CITY OF ALBUQUERQUE

RE: MDS OS-7 Storm Drain Relocation

Grading and Drainage Report Stamp Date: 5/4/21

Hydrology File: R16D097A

EXHIBIT D -GRADING PLAN

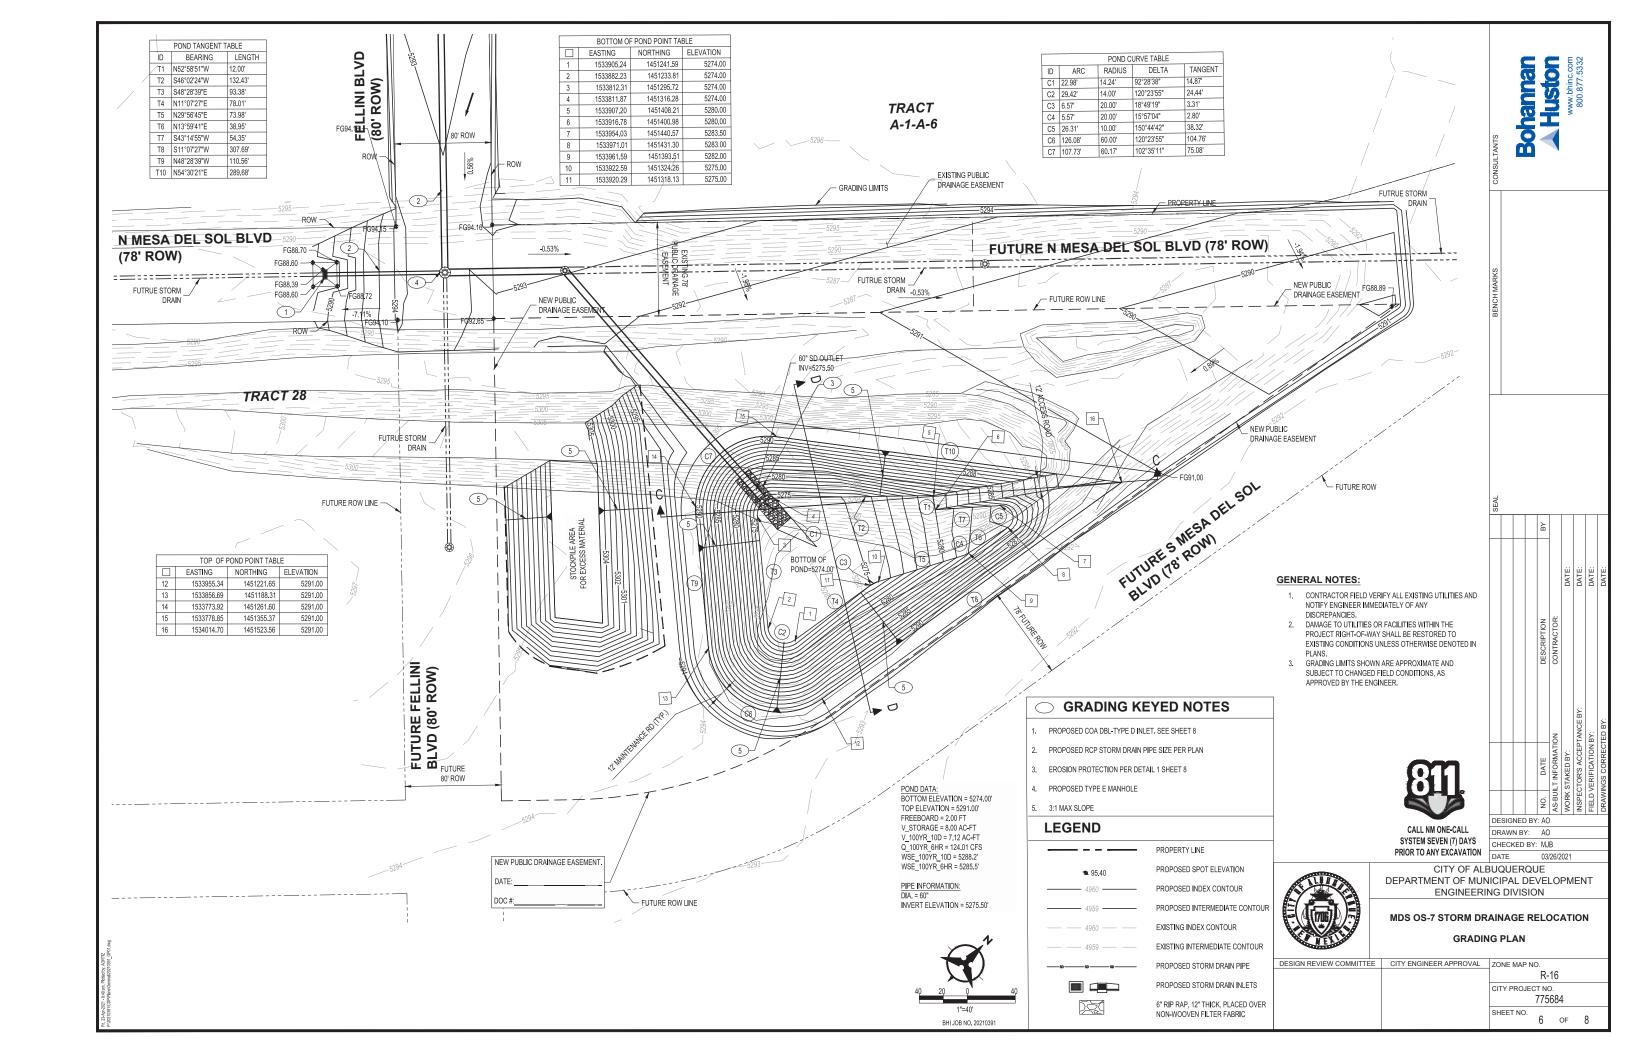
Please note, at DRC a note must be added to the pond grading sheet stating that pond slopes are

to be stabilized with "Native Grass Seed with Aggregate Mulch or equal (Must satisfy the "Final

Albuquerque Stabilization criteria" CGP 2.2.14.b.).
